# Rezoning Transportation Analysis

Petition Number: 2025-034

## Revision Log:

Date	Description
4-23-25	First Review (NK)
5-21-25	Second Review (NK)
7-23-25	Third Review (NK)
8-12-25	Fourth Review (NK)
8-26-25	Fifth Review (NK)

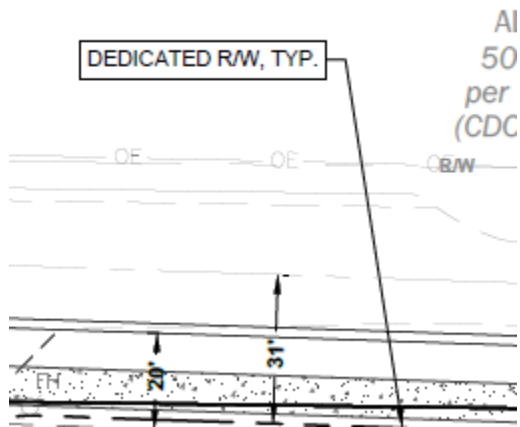
- c. ~~Providence Road:~~ The future location of back of curb and gutter is 44' from road centerline. The existing curb can remain in its current location.

~~6+ Boulevard with 12' shared use path and 8' planting strip~~

~~Label and dimension the curb and gutter from the centerline for each road on the site plan.~~

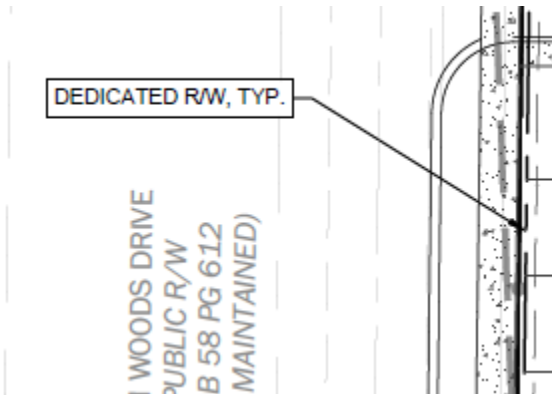
- ~~4. Revise site plan and conditional note(s) to commit to dedicate 33.5' right-of-way from the Allison Woods Drive centerline. The site plan shall label and dimension the right-of-way from the road centerline. Additionally, 2' SUE must be added from the back of sidewalk.~~

**Clarifying Comment 5-21-25:** ~~Dedicated ROW must be dimensioned with a distance. For a residential medium, 31' of right-of-way must be dedicated or 29' right-of-way with a 2' SUE. Please ensure conditional note and sight plan align.~~

d. Petitioner shall dedicate 29' of right-of-way from the centerline of Allison Woods Drive.
